Subject: McGuire Nuclear Station, Unit 1  
Docket No. 50-369  
Request for Additional Information  
TAC No. M89625/6

By submittal dated May 18, 1994, Duke Power Company proposed the integration of the McGuire Nuclear Station Unit 1 Reactor Vessel Material Surveillance Program with that of the Diablo Canyon Unit 2.

To this end, find enclosed the Duke Power Company response to the request for additional information as received by FAX on January 6, 1995.

Figure 5-19.  
Relationship Between Reactor Coolant System Temperature and Power

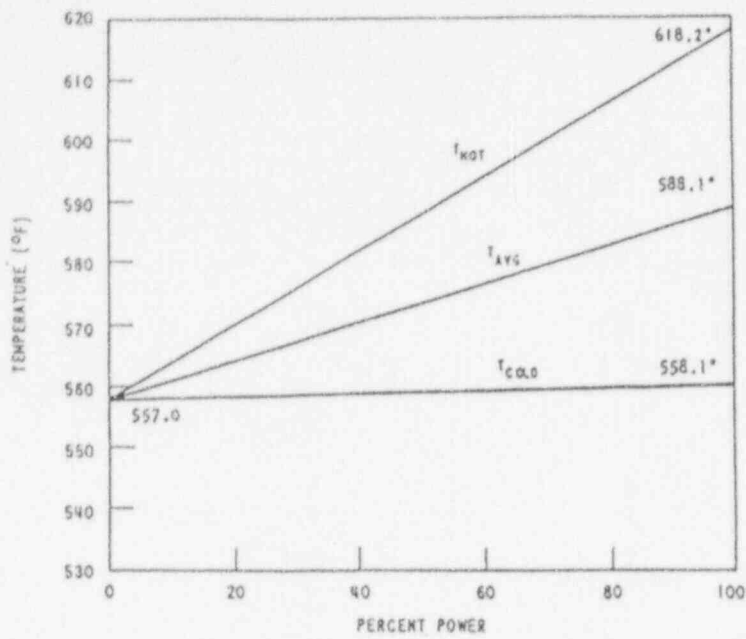
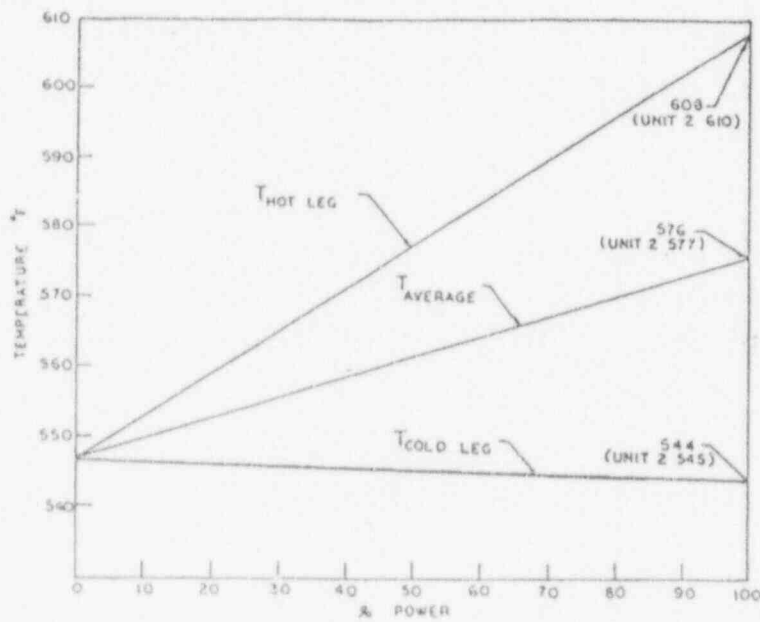
- 3) Provide the vessel inlet temperature for each fuel cycle at McGuire Unit 1 and Diablo Canyon Unit 2 because the staff does not know how and where those two Temperatures on Page D-6 were obtained.

As shown in figure 5-19 of the McGuire FSAR, T<sub>cold</sub> remains fairly constant at approximately 558F. A Licensee Event Report search indicated the Technical Specification was violated once. The minimum NC system temperature of 536.7F was reached during a 79 minute event. This event is documented in the Duke Power Company, McGuire Nuclear Station Reportable Occurrence Report No. 370/83-62, dated December 1, 1983.

Diablo Canyon Unit 2 reported no significant operating temperature deviations (operating below 525F) in GL92-01 submittal. Their OP L-1 requires T<sub>ave</sub> = 547F prior to entering Mode 2. OP L-5 requires T<sub>ave</sub> > 541F until reactor is subcritical.

Attached are the McGuire and Diablo Canyon Reactor system temperature versus power curves found in chapter 5 of the FSAR.
